Access Compliance Report

Public Rights-of-Way

(Curb Ramps)

Intersection ID: 21458	Main Street: PROVIDENCE_RD	Cross Street: SARDIS_LN	Location: SE
ADA ID: 9AC836120DB8	Ramp Type: PerpDiag	Initial Pass/Fail: Fail	Overall Compliance: No
Codes/Mitigation Info/Possible Solution		Field Measurements/Component Compliance	
Severity Score: 31.25

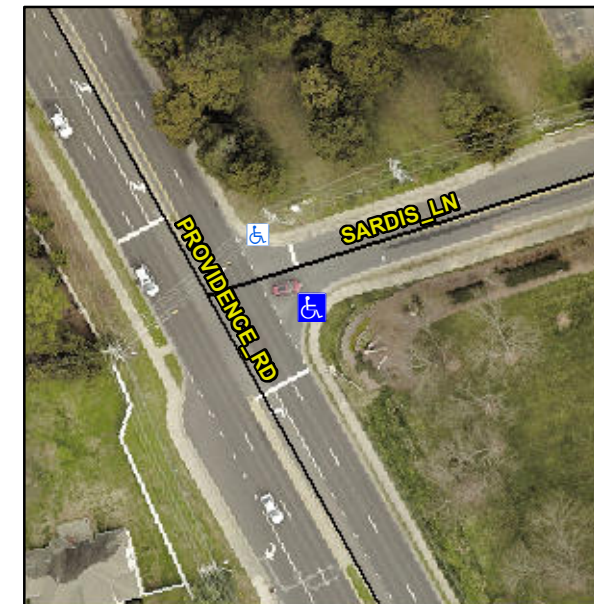
Not Found, R304.5.1, R304.2.2, R304.5.3

Compliance	Description	Data	Compliance	Description	Data
N/A	Ramp Length (in)	85.0	No	Ramp Slope (%)	9.2
No	Ramp Width (in)	33.0	No	Ramp XSlope (%)	2.7
N/A	Flare Type LT	N/A	N/A	Flare Type RT	N/A
N/A	Flare Slope LT (%)	N/A	N/A	Flare Slope RT (%)	N/A
N/A	Flare Traversable LT?	N/A	N/A	Flare Traversable RT?	N/A
N/A	Landing Length (in)	N/A	N/A	DWS Provided?	N/A
N/A	Landing Width (in)	N/A	N/A	DWS Contrast?	N/A
N/A	Landing Slope (%)	N/A	N/A	DWS Length (in)	N/A
N/A	Landing X Slope (%)	N/A	N/A	DWS Full Width?	N/A
N/A	Landing Curb? (Y/N)	N/A	N/A	DWS Offset (in)	N/A
N/A	Shared Landing?	N/A			
N/A	Gutter Ponding?	N/A	N/A	Gutter Slope (%)	N/A
N/A	Gutter Lip Ht (in)	N/A	N/A	Gutter X Slope (%)	N/A
N/A	Painted X Walk1?	No	N/A	Painted X Walk2?	No
	X Walk 1 Direction	To NW		X Walk 2 Direction	To W
N/A	X Walk 1 Width (in)	N/A	N/A	X Walk 2 Width (in)	N/A
	X Walk 1 Slope (%)	2.9		X Walk 2 Slope (%)	0.2
	X Walk 1 X Slope (%)	2.5		X Walk 2 X Slope (%)	3.9

Remove & Replace Curb Ramp With Two New Directional Ramps or Equivalent.
